Errata to Draft EIR

Final Revised Environmental Impact

Report for the Pebble Beach Company Project

May 2012

In Appendix D.2: Draft Del Monte Forest Land Use Plan Figures, Figures 5 and 6e have been revised to show the correct boundary for the Huckleberry Hills Natural Habitat Area (HHNHA).

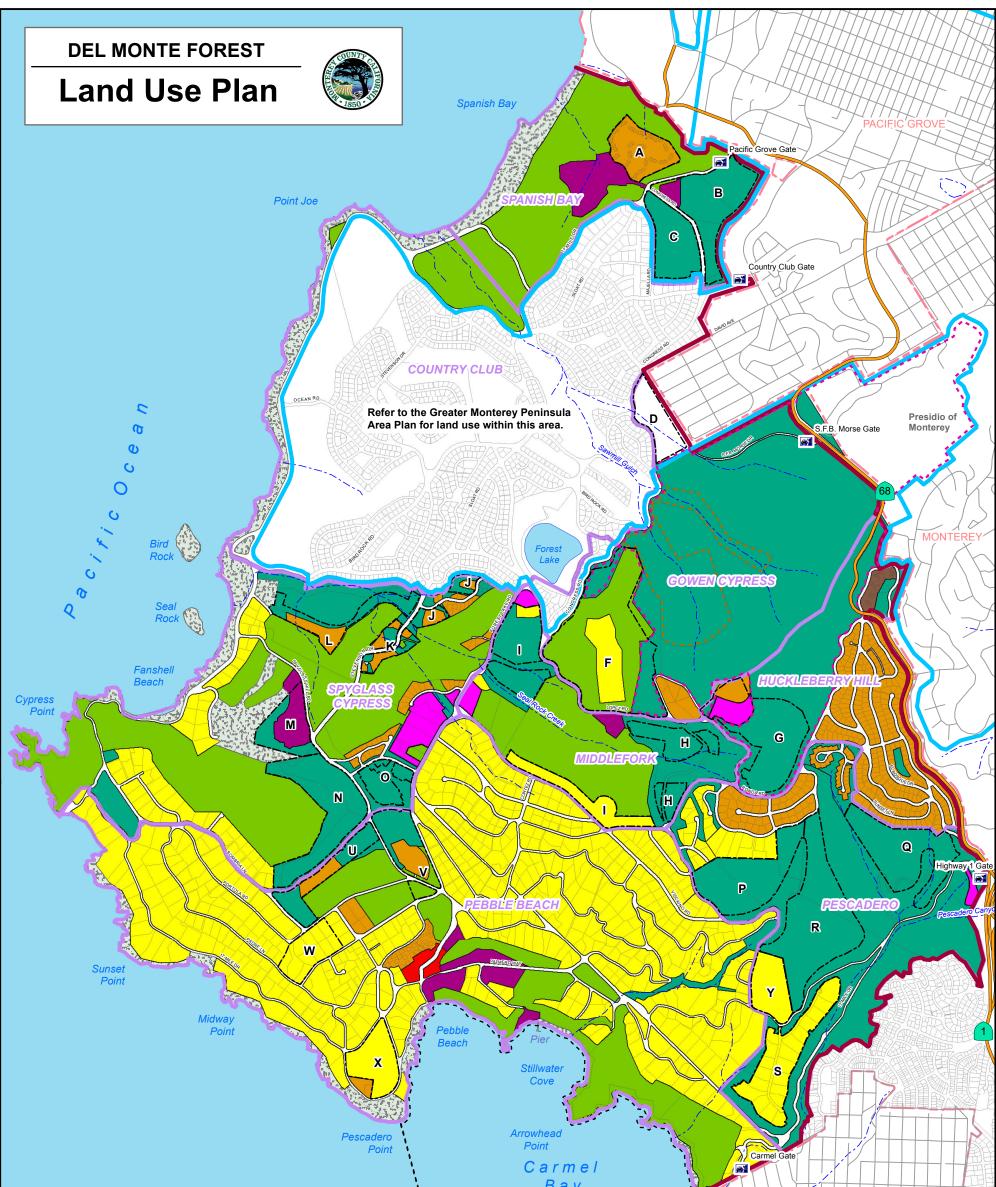
The boundary of the HHNHA was corrected to remove the 1.45-acre area that is actually in the Corporation Yard area. There was a drafting error in the County's proposed land use map that showed the 1.45-acre area as within the HHNHA (as shown in Figures 5 and 6e included in Appendix D.2 of the Draft EIR). This has been corrected (as shown in Figures 5 and 6e included in this Errata). This correction was identified by the California Coastal Commission staff, and was considered by the Commission prior to its decision on May 9, 2012, to certify the Local Coastal Program Amendment.
